Planning Commission and Neighborhood Comment Responses

Re: Statement of Compliance for Christ Community Chapel's Planning Commission
Submission for the Field and Outdoor Restroom

Field and Outdoor Restrooms
**CHRIST COMMUNITY
CHAPEL**
750 W Streetsboro St
Hudson, OH, 44236

RE: Christ Community Chapel's Turf Field and Outdoor Storage

SPECTATOR SEATING OPTION 2 - TWO U10 GAMES

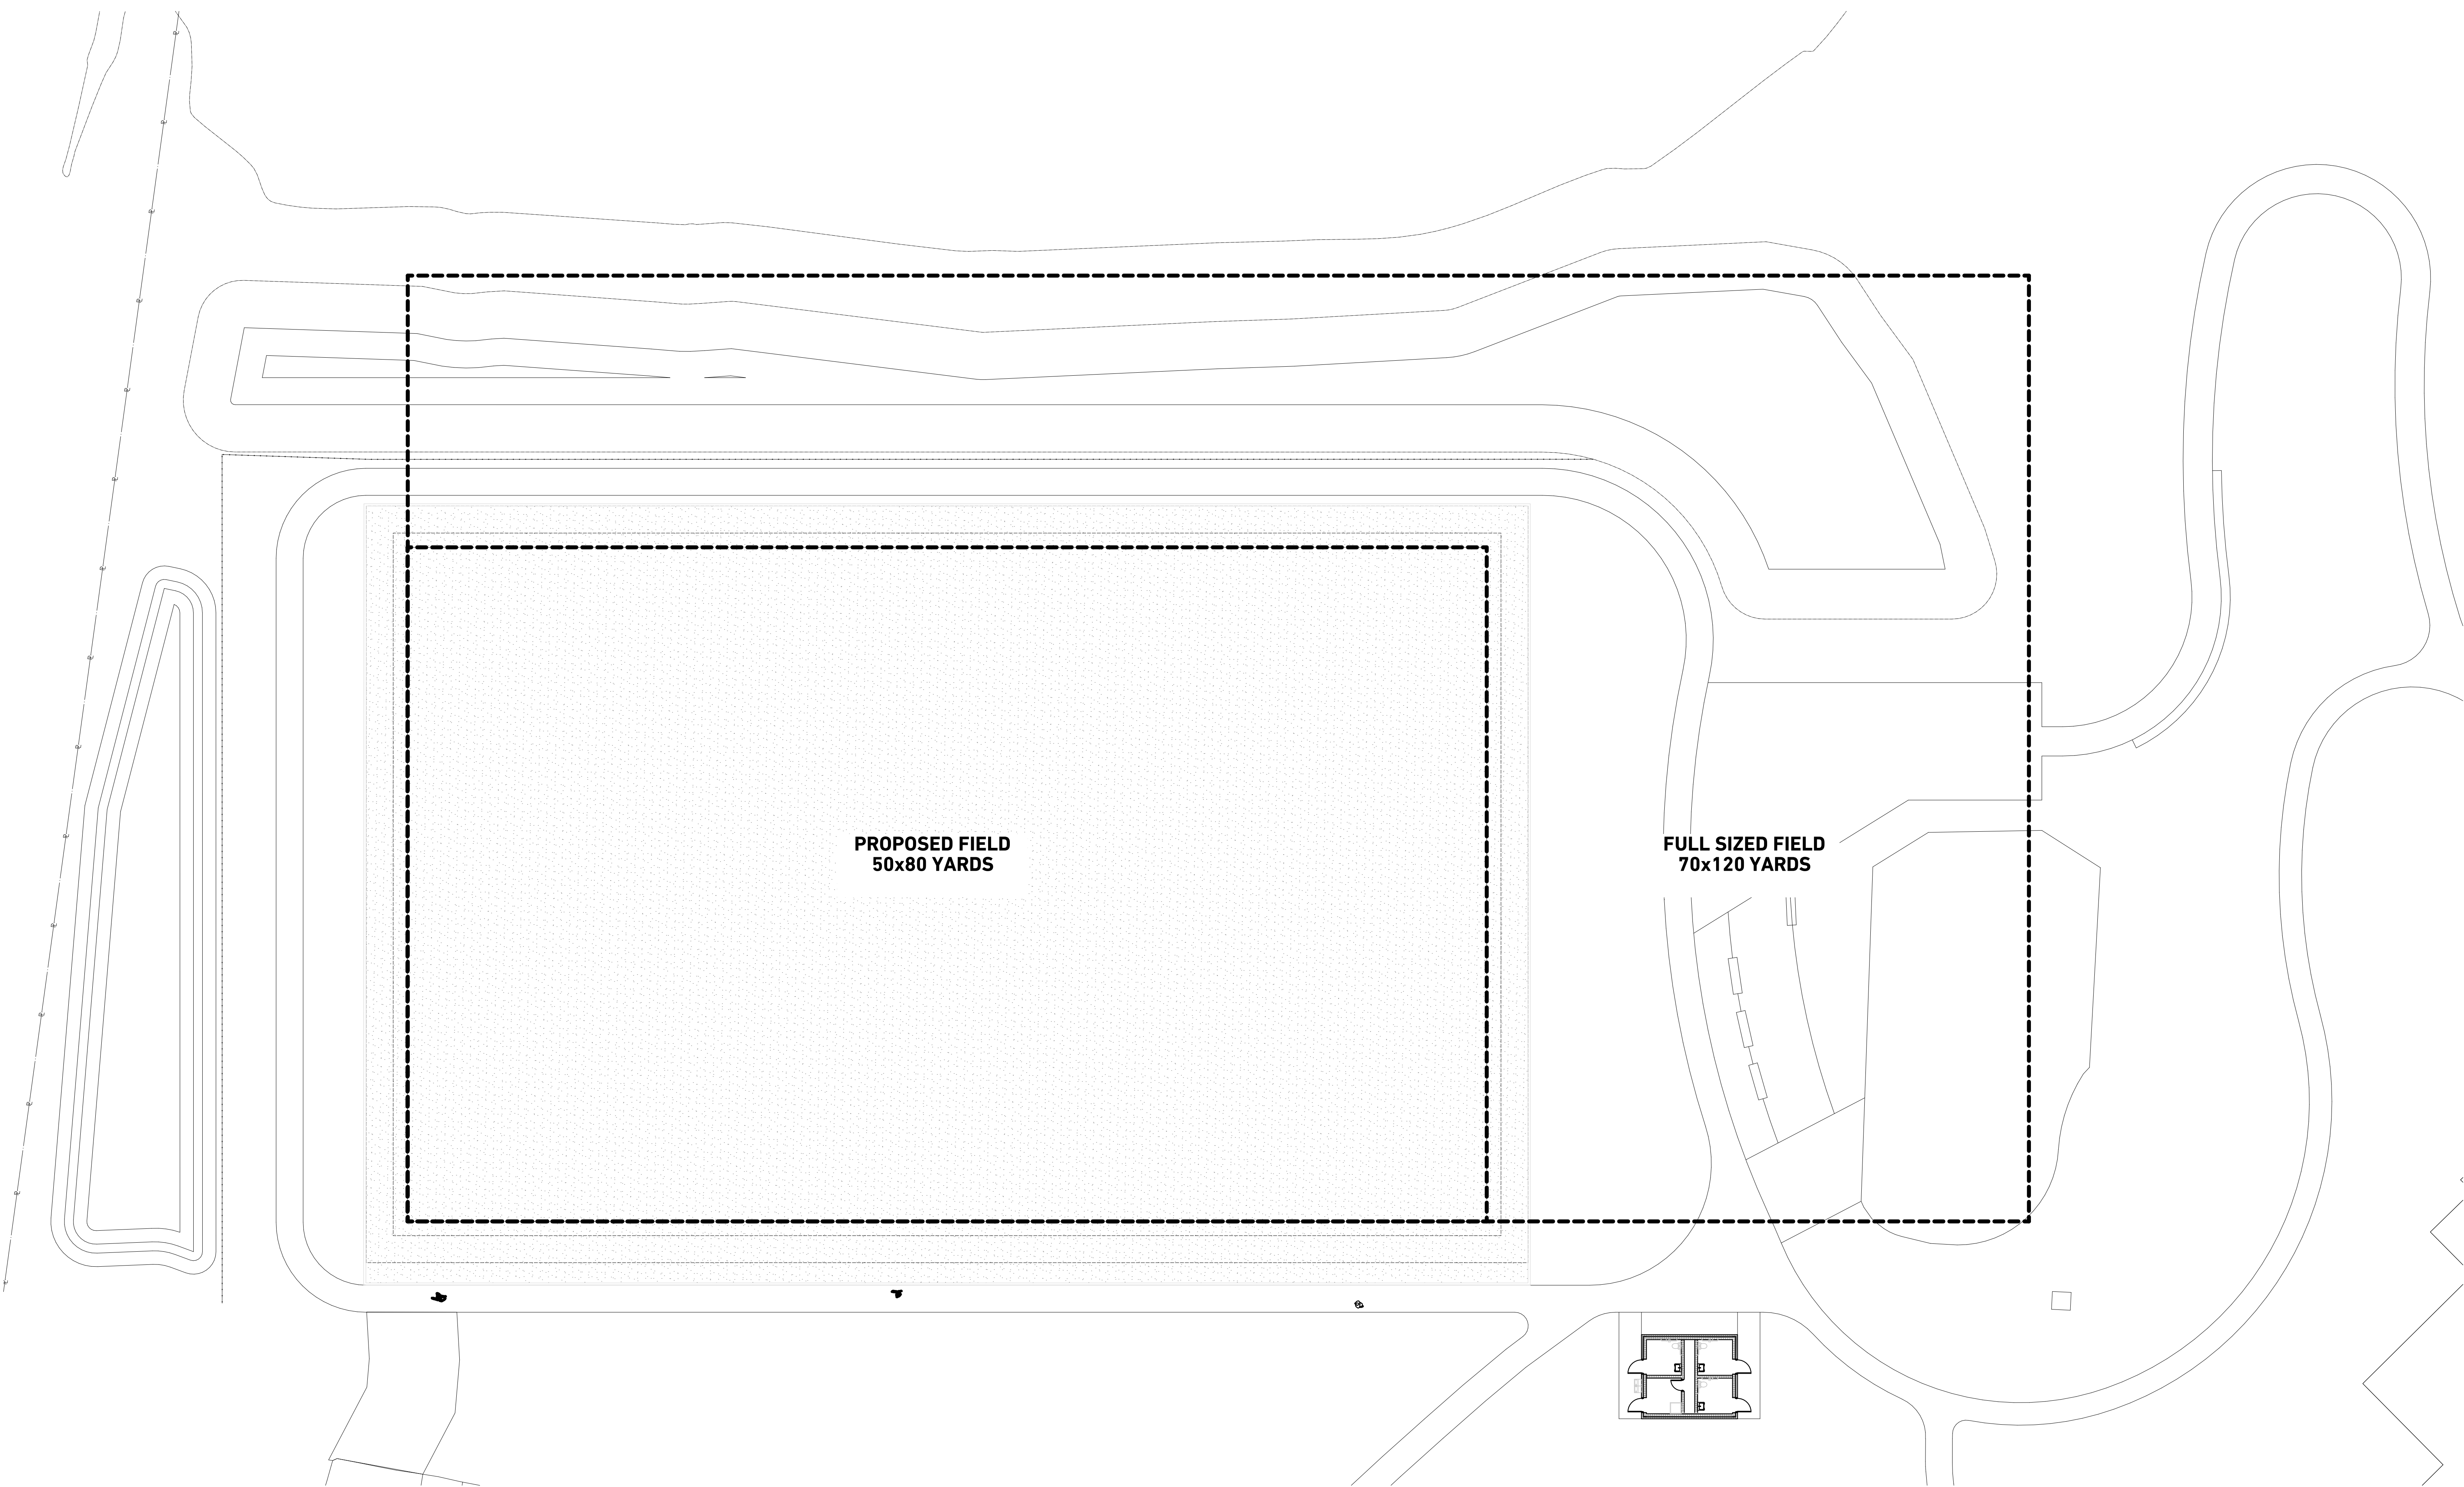
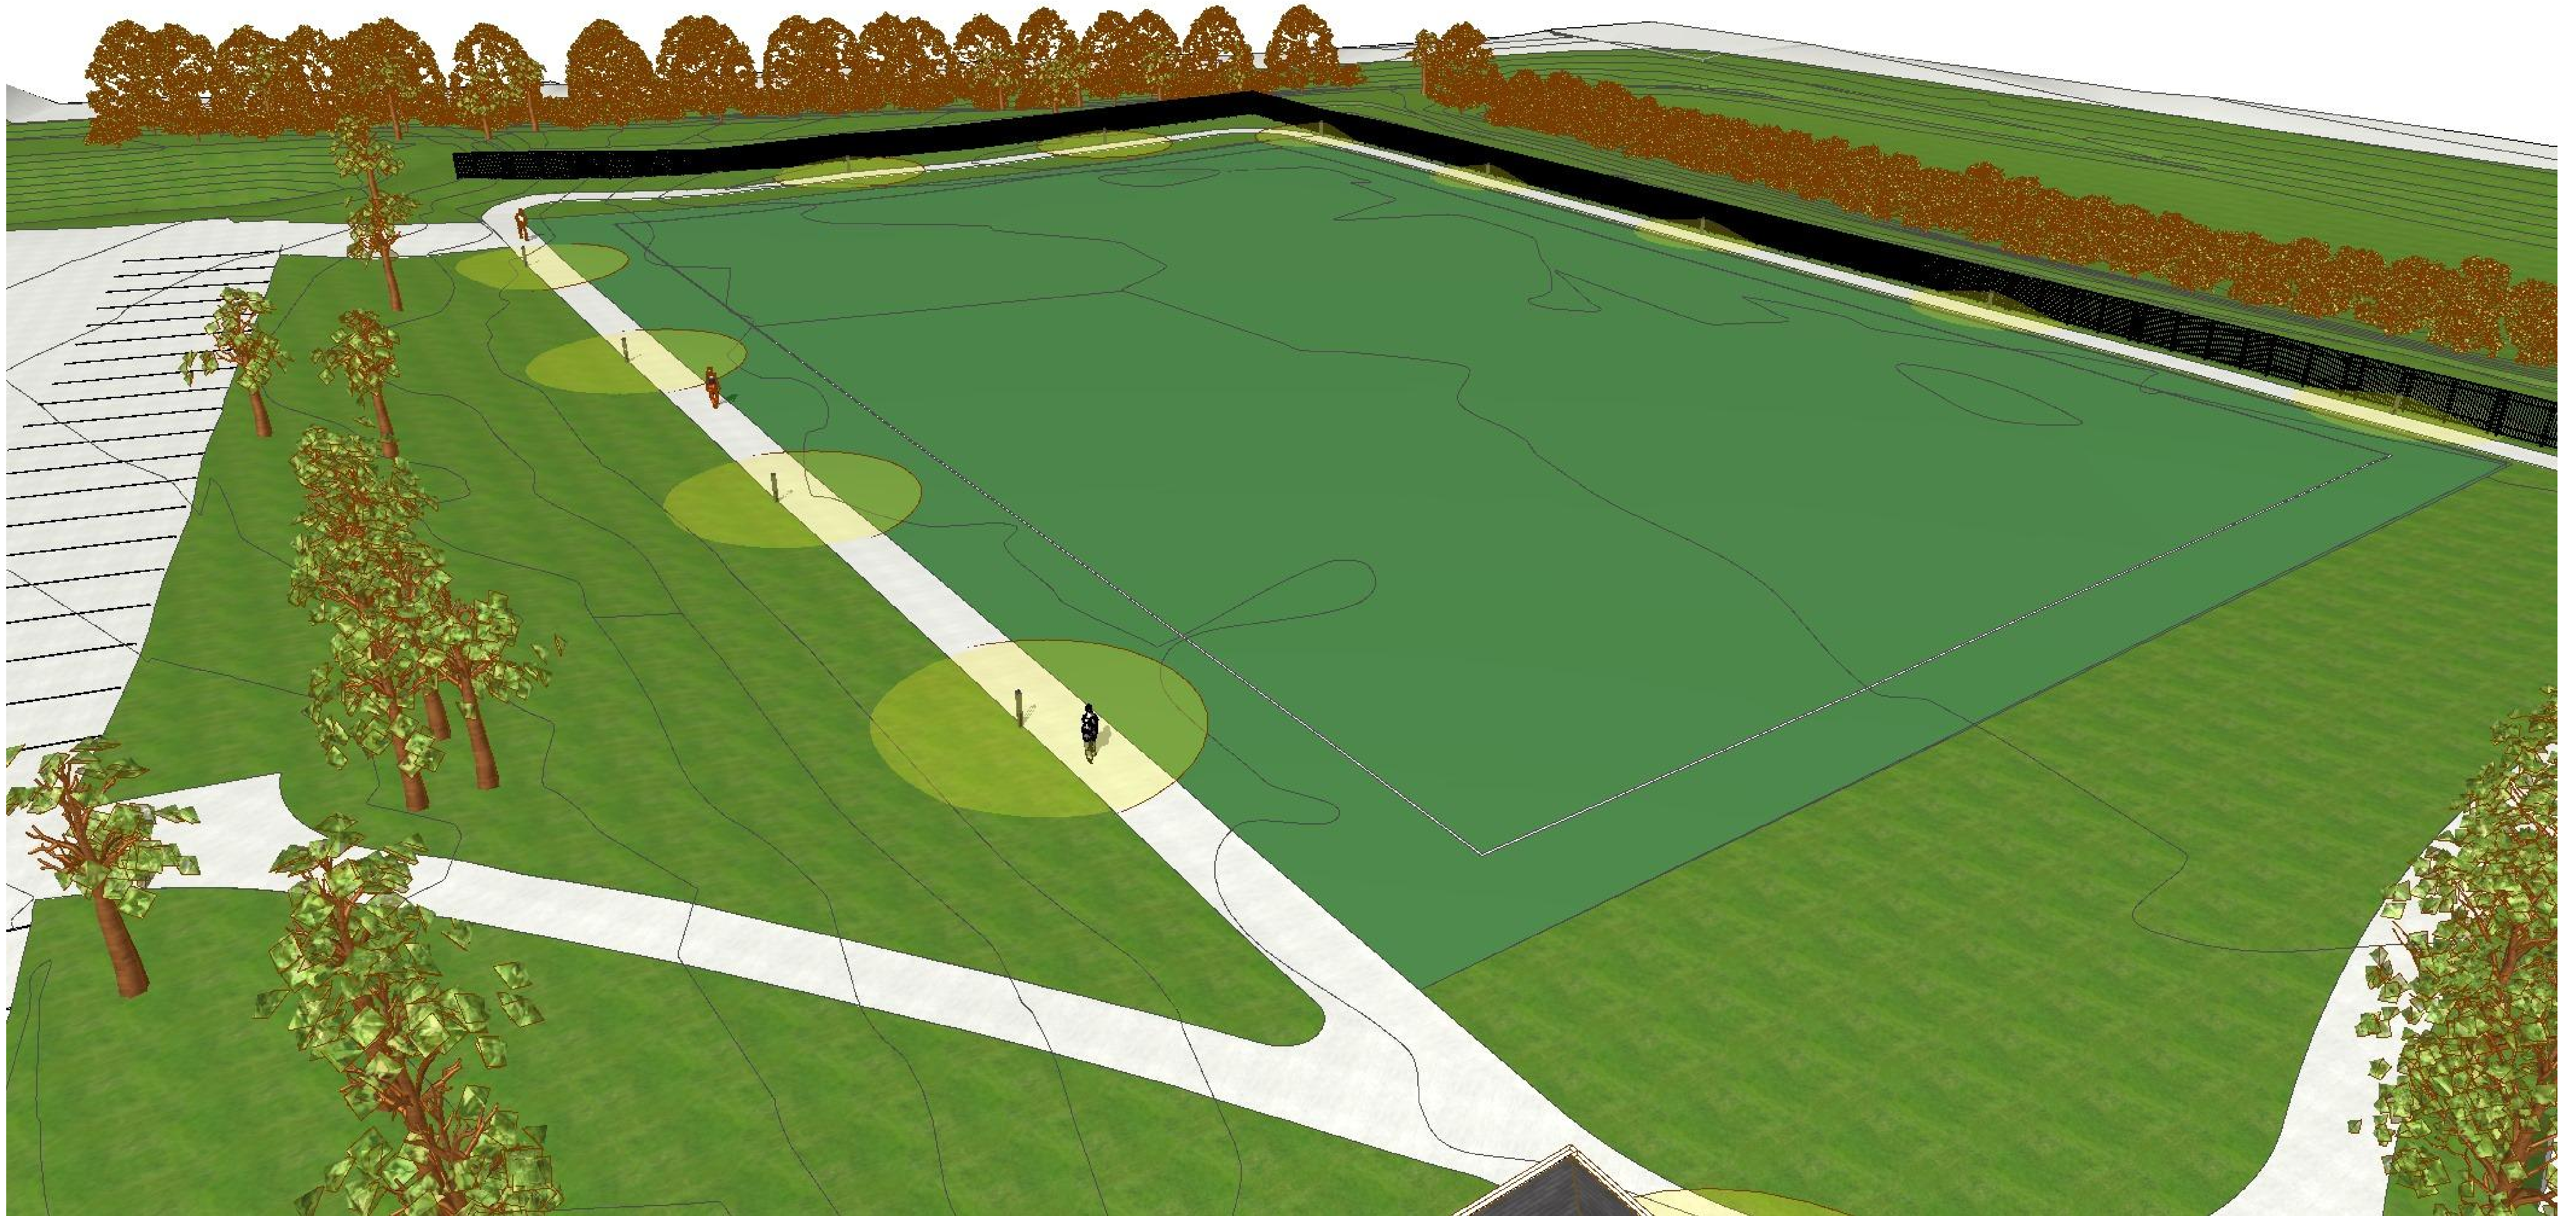
Spectator accommodation: There is adequate room in and around the perimeter of the field for the number of spectators that would likely attend an event to utilize their own lawn chairs or other personal seating to view events. Please refer to the spectator seating diagrams for additional information.
